Subject: Safety Recall BLC (Interim B2C) - **Interim Notice**
Certain 2004 - Early 2007 Model Year RX 330, RX 350 and RX 400h Vehicles
Driver's Side Floor Carpet Cover and Retention Clip

**Certain 2004 – 2007 Model Year RX330/350/400h
Floor Carpet Cover and Retention Clip
Safety Recall Notice (*Interim Notice*)**

Safety Recall BLC - Q&A
Certain 2004 - Early 2007 Model Year RX 330/350/400h
Driver's Side Floor Carpet Cover and Retention Clips

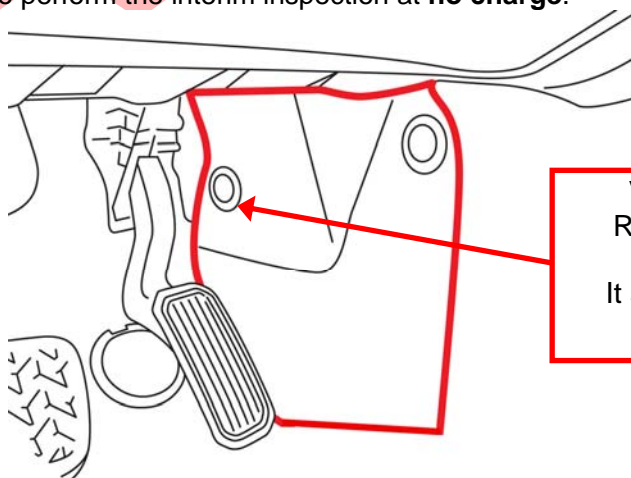
In certain 2004 through 2007 model year RX330/350/400h vehicles, if the forward retention clip used to secure the driver's side Floor Carpet Cover, which is located in front of the center console, is not installed properly, the cover may lean toward the accelerator pedal and interfere with the accelerator pedal arm. If this occurs, the accelerator pedal may temporarily become stuck in a partially depressed position rather than return to the idle position. An accelerator pedal temporarily stuck in a partially depressed position may increase the risk of a crash.

Once the remedy parts are available, Lexus will replace the Floor Carpet Cover with one of a different shape as well as the forward and rear retention clips. ***Lexus will send a second owner notification letter when the replacement parts are ready and preparations are complete.***

Verify that the Forward Retention Clip is properly installed. It should not be missing or loose.
